SECTION 009113 – ADDENDUM FOUR

- A. Project Name: 22062 Picayune Multipurpose and Band Hall Renovation
- B. Owner: Picayune School District, 706 Goodyear Blvd., Picayune, MS 39466
- C. Architect: Dale | Bailey, an Association, 188 E. Capitol Street, Suite 250, Jackson, Mississippi, 39201
- D. Architect Project Number: 22062
- E. Date of Addendum Four: 13 July 2023

Picayune High School Multipurpose and Band Hall Renovation 22062 Picayune Multipurpose and Band Hall Renovation Picayune, MS

PLAN NOTES

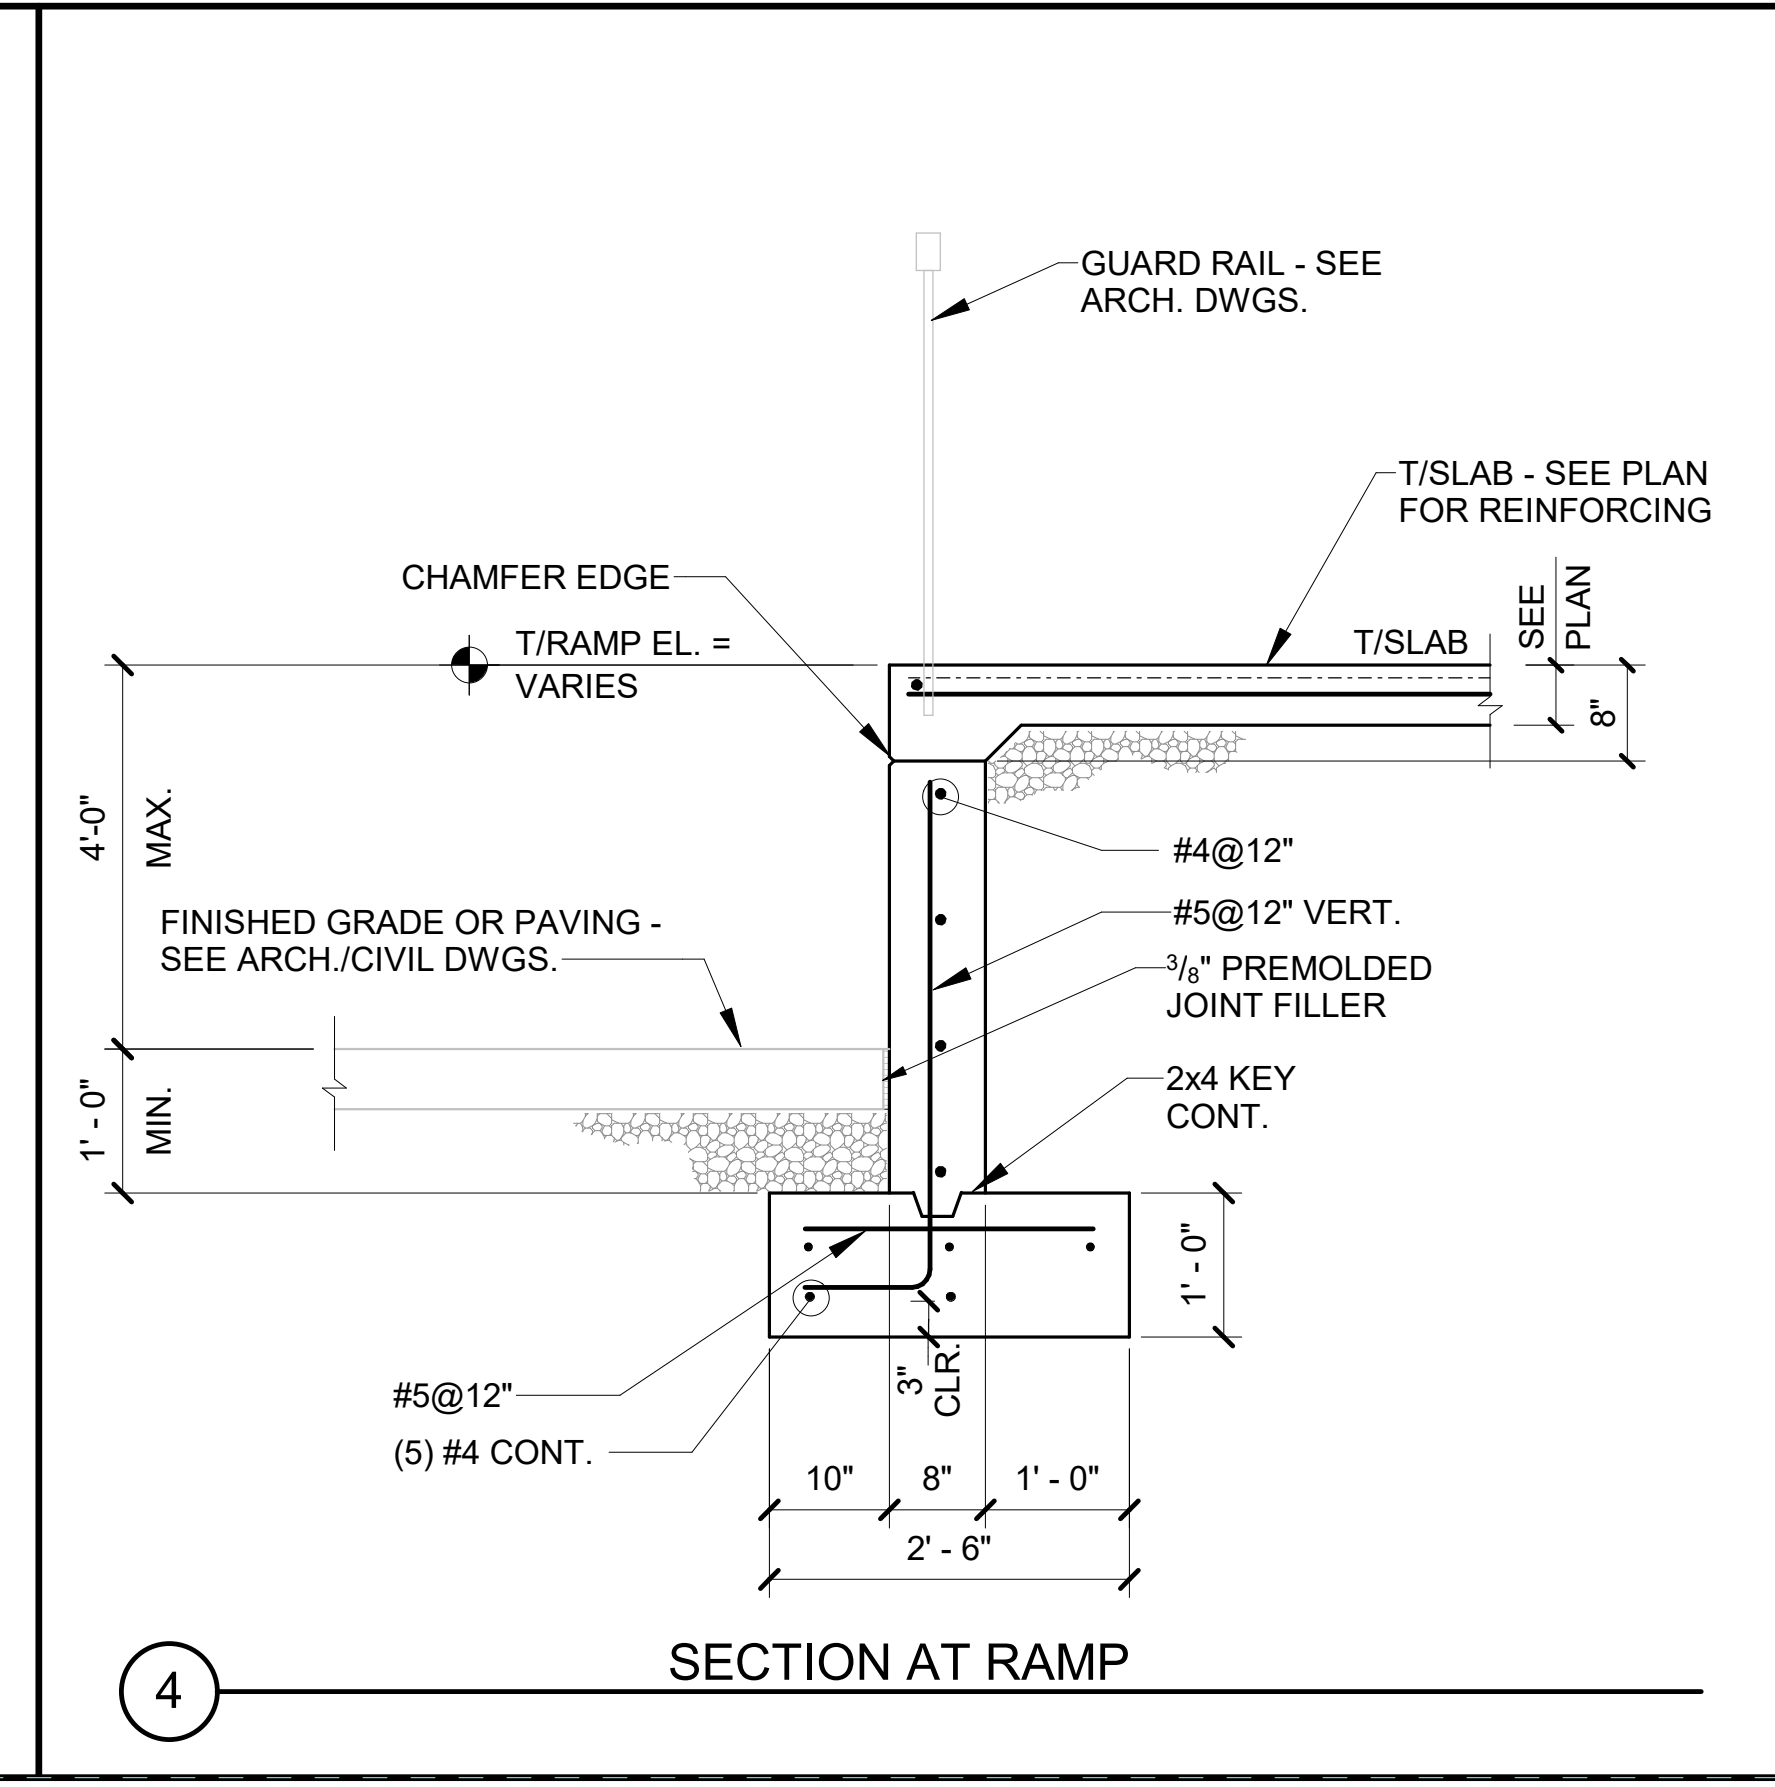
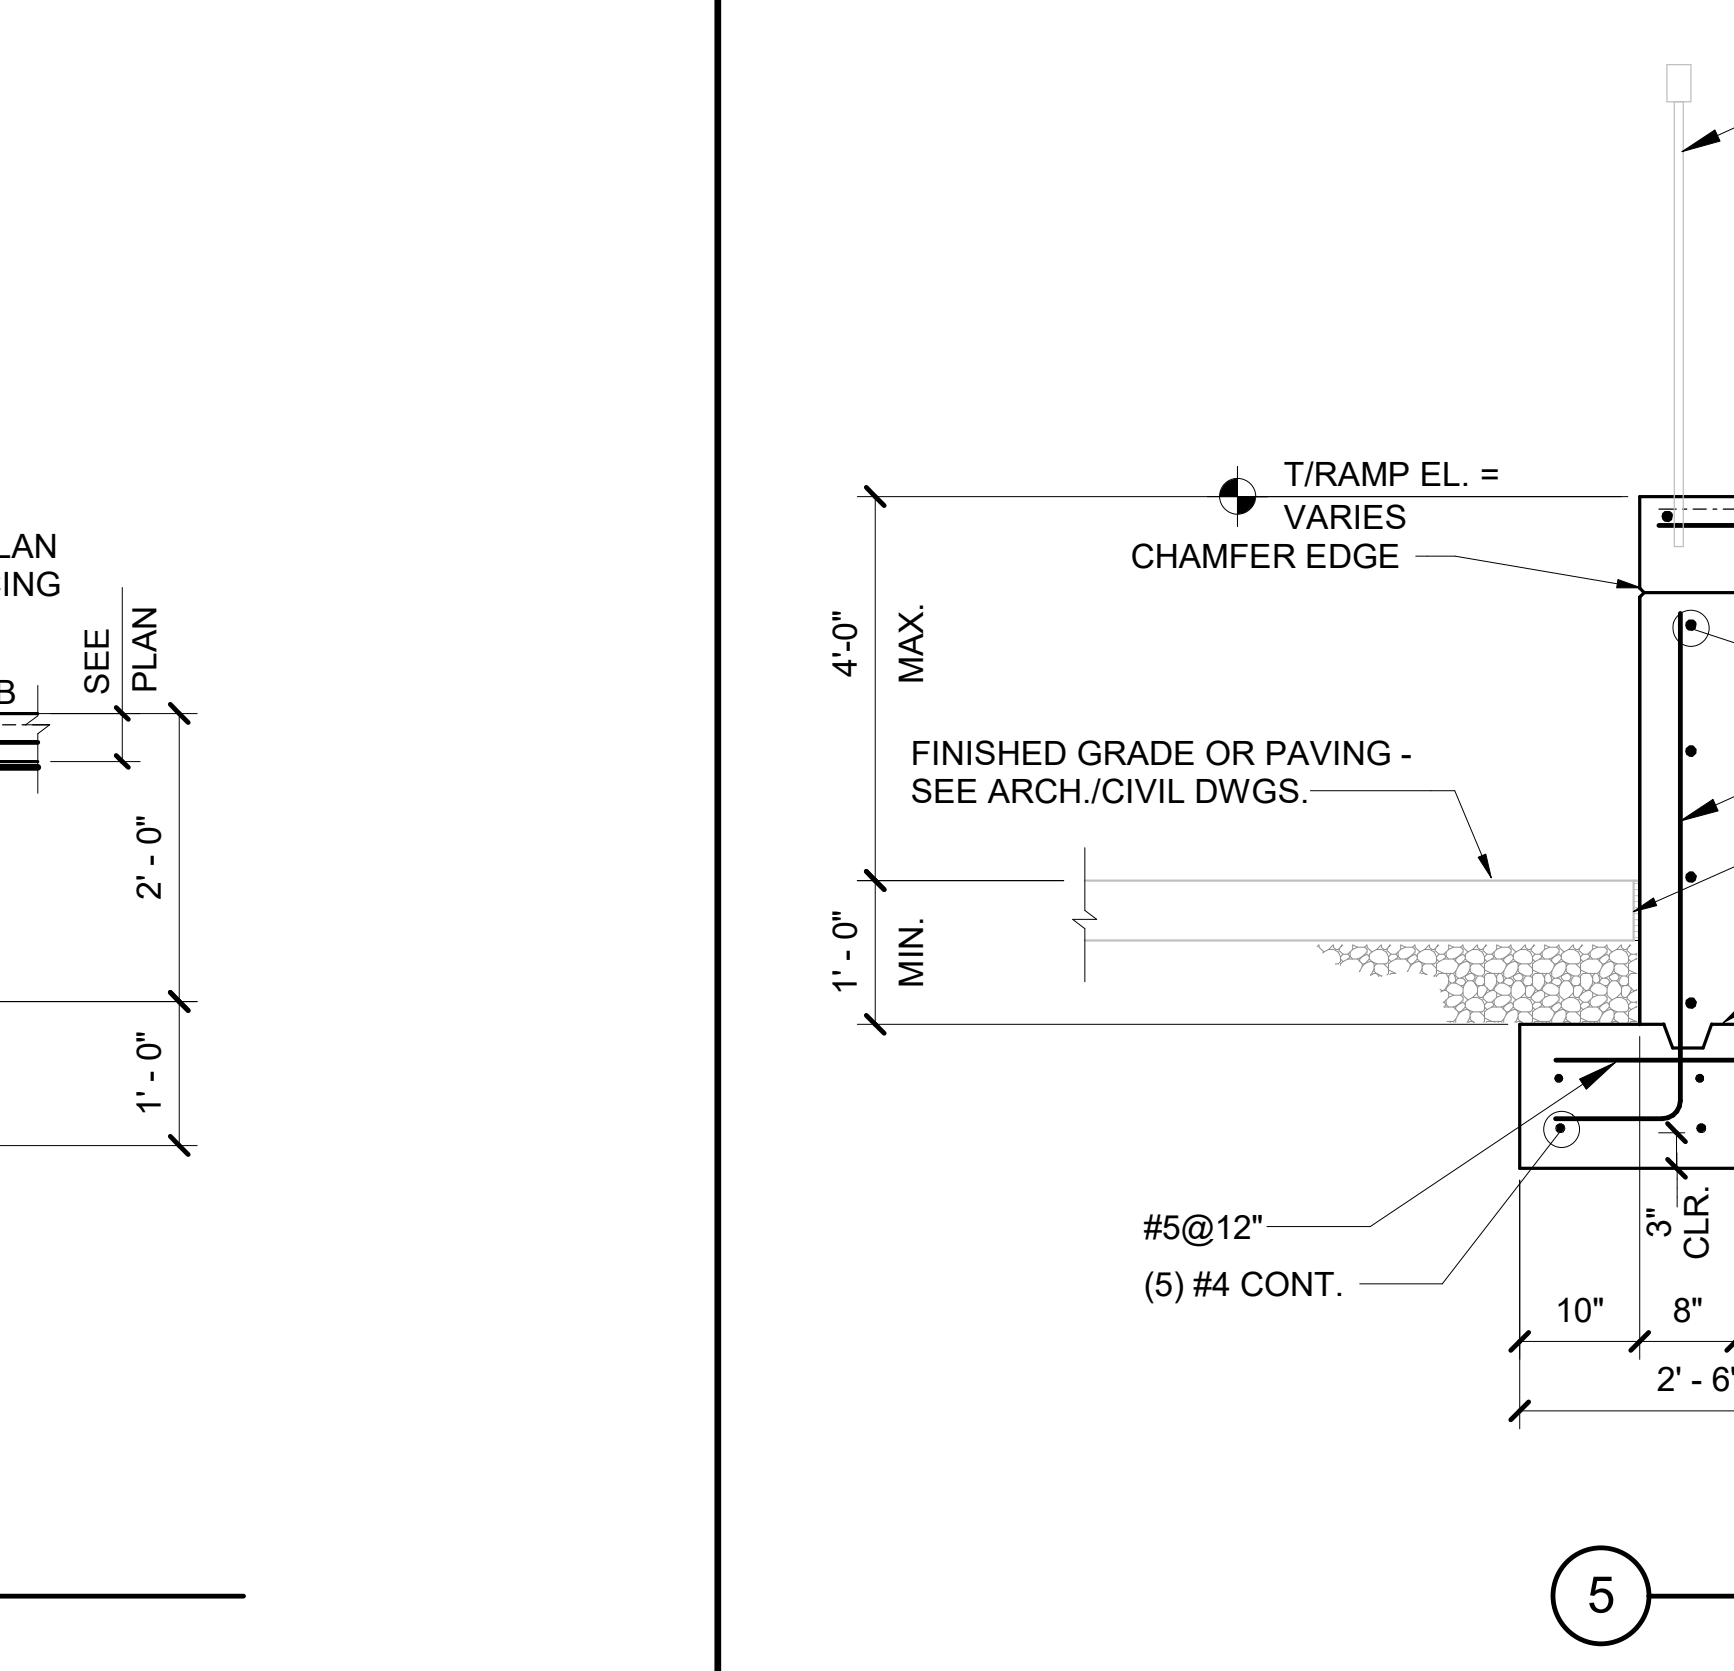
- A. Sheet S-003 – Structural Quality Assurance Plan (Not Re-Issued). Under General, 3rd paragraph: Special Inspector will be hired by the Owner.
- B. Sheet S-101 – Foundation Plans (Re-Issued). Delete this sheet in its entirety and replace it with the attached. Added foundation wall and footing to east side of building along with new sections (7/S-203, 8/s-203, 9/S-203 and 10/s-203) detailing wall and footing.
- C. Sheet S-203 – Foundations Sections and Details (Re-Issued). Delete this sheet in its entirety and replace it with the attached. Added details 7/S-203, 8/s-203, 9/S-203 and 10/s-203.

1
E-201 POWER PLAN - MULTIPURPOSE BUILDING
Scale: 1/8" = 1'-0"

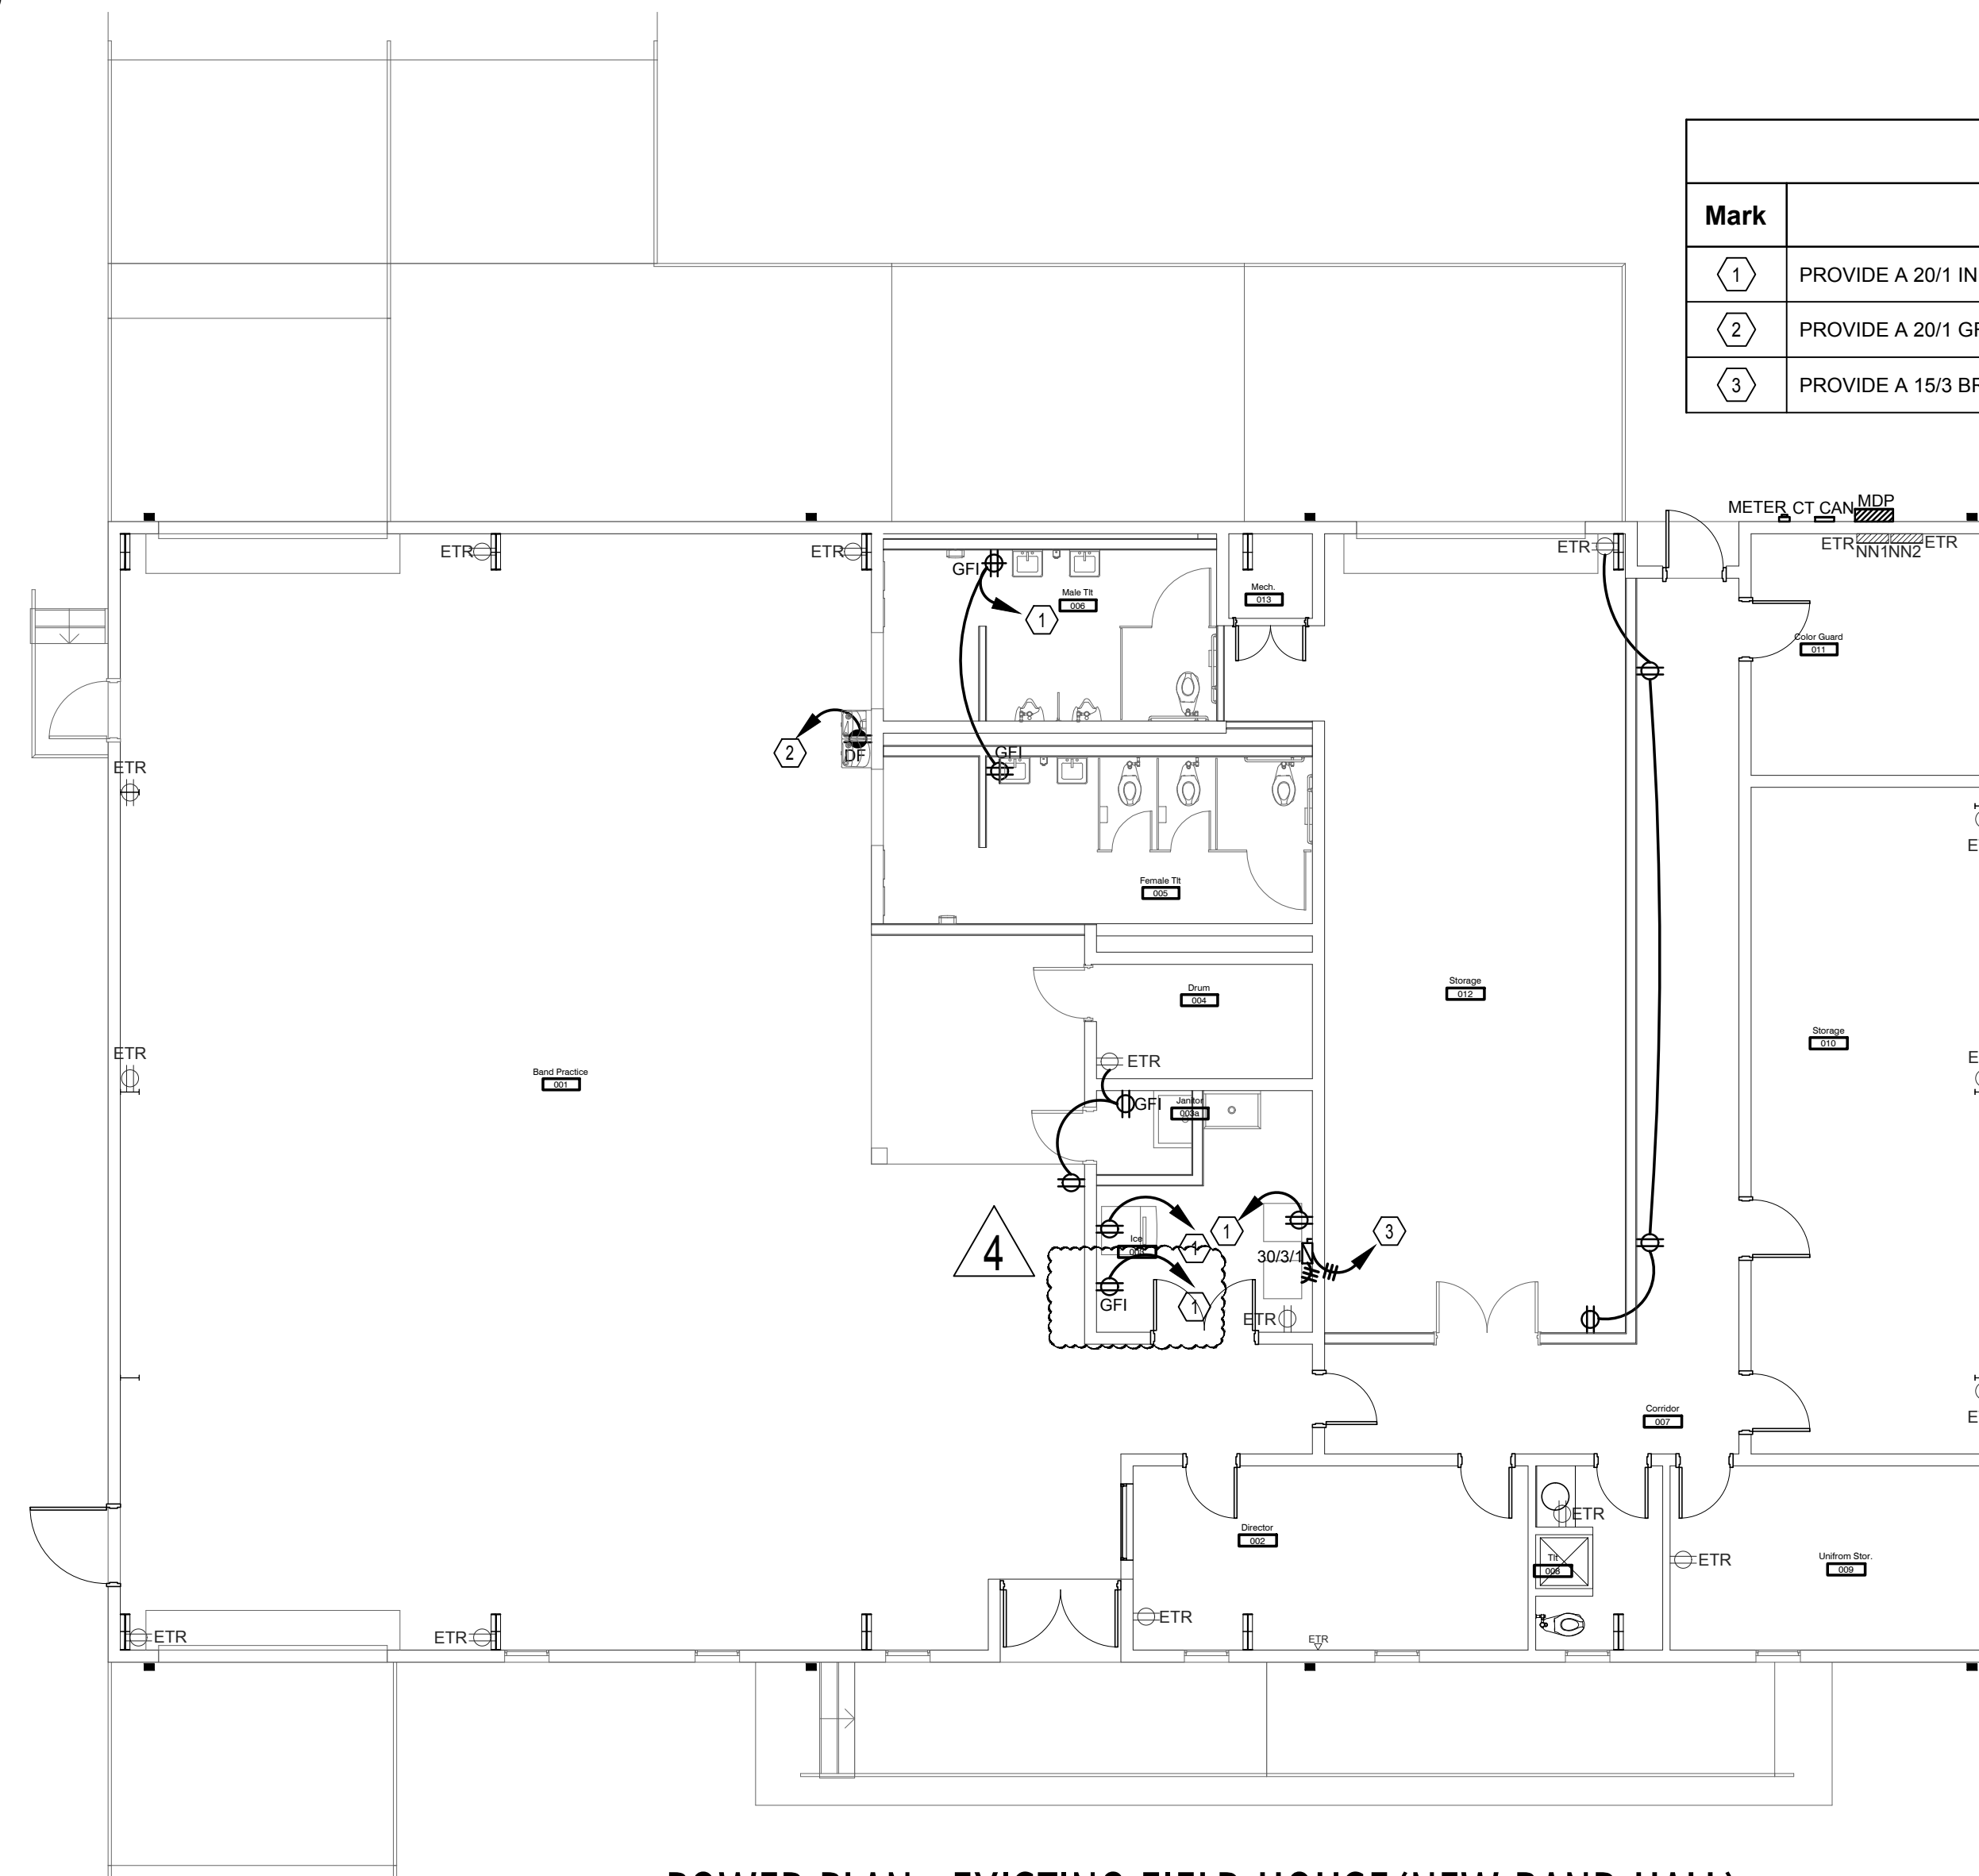
- D. Sheet E-003 – Panel Schedules (Re-Issued). Delete this sheet in its entirety and replace it with the attached. Added Owner requested outlets.
- E. Sheet E-201 – Power Plan (Re-Issued). Delete this sheet in its entirety and replace it with the attached. Added Owner requested outlets.
